**N4010A-09**

**S E R V I C E N O T E**

**N4010A Wireless Connectivity Test Set**

**Firmware Defect May Affect The N4010A Noise Floor**

Figure 2

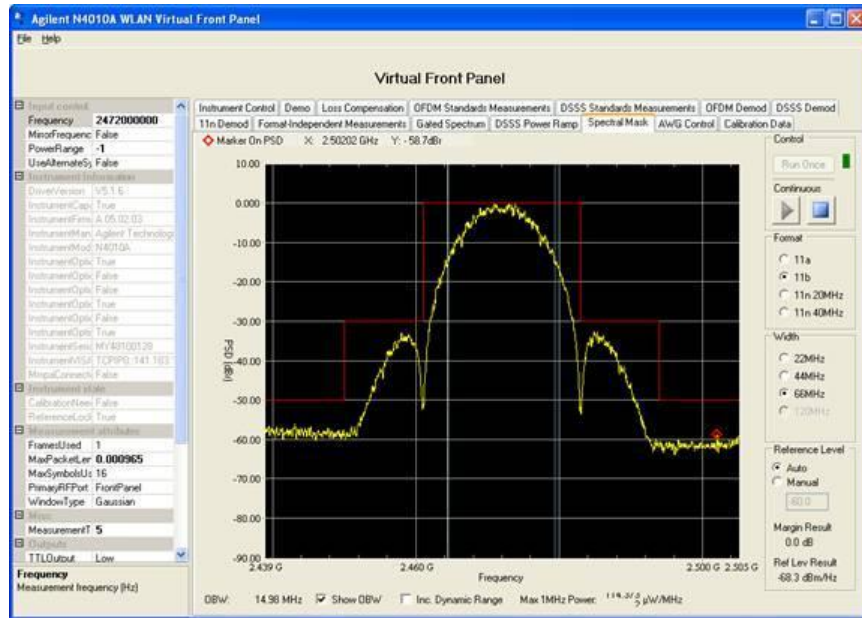
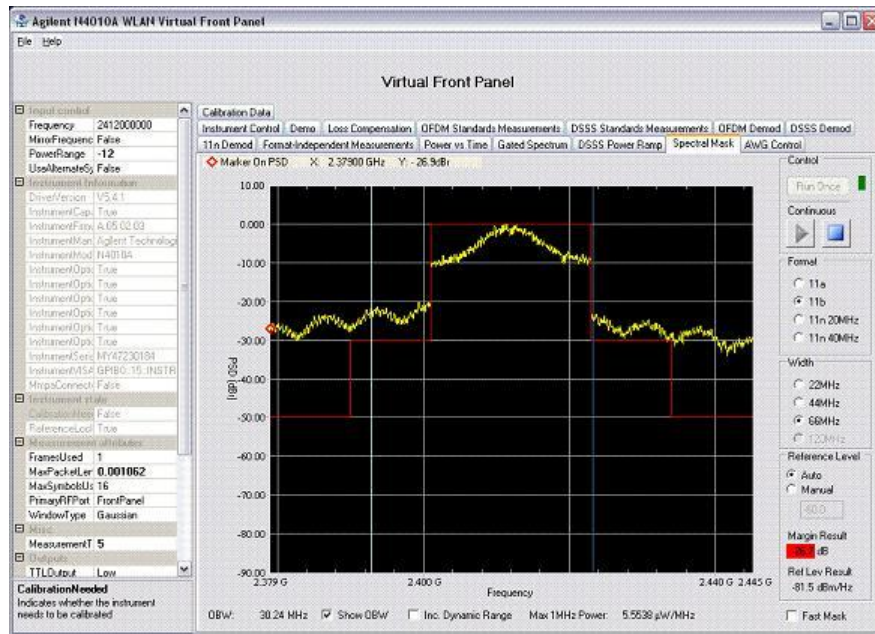
A firmware defect has been found that may cause the noise floor of the N4010A to shift by as much as +30dB; when this happens the instrument will fail measurements such as spectral mask, even on a good device. This defect is present in all firmware revisions prior to A.05.03.10.

1. Connect the N4010A to an 802.11b WLAN device, and configure the device to transmit a repeated signal.
2. Launch the N4010A 'Virtual Front Panel' software; create a connection between the software and the N4010A.
3. Select the 'Instrument Control' tab; auto-range & set the power level for an 802.11b signal.
4. Select the 'Spectral Mask' tab; select 'Format 11b', 'Width 66MHz', and click on 'Run Once'.
5. If the spectral mask result is similar to Figure 1, then the fault is not present in this instrument.
6. If the spectral mask result is similar to Figure 2, then the fault is present in this instrument.

This fault can be fixed by simply upgrading the N4010A firmware to revision A.05.03.10 (or later).
